## ***Architect's Supplemental Instructions***

**Instruction Number: ASI B01**

**PROJECT:** DBH OLIVE AVE ROOF REPLACEMENT AND FAÇADE REPAIRS  
5555 E. OLIVE AVE, FRESNO, CA 93727  
Contract No.: 24-S-08

DETAIL REPLACES K1/A-803

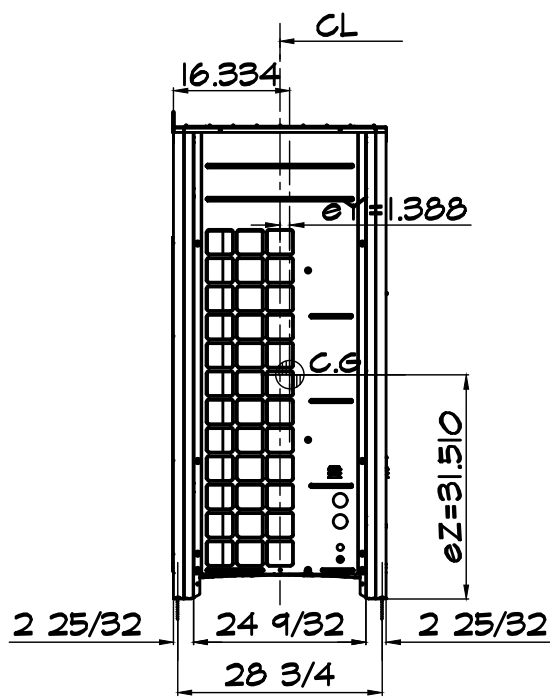
1. REPLACE DETAIL K1/A-803 WITH DETAIL SHOWN ON PAGE 2 THIS ASI.
2. PROVIDE PLATFORM FRAMING PER THE FOLLOWING DETAILS AT ROOF-MOUNTED OUTDOOR UNITS AS INDICATED ON PROPOSED ROOF PLAN, DETAIL A2/A-202.1, KEYNOTE 14. REFER TO DETAIL A3/A-A802 SIM FOR ROOFING AND GALVANIZED SHEET METAL CAP.
  - a. DETAIL 1 – ODU 4 DIMENSIONS
  - b. DETAIL 2 – ODU CURB FRAMING PLAN
  - c. DETAIL 3 – ODU CURB MOUNTING DETAIL
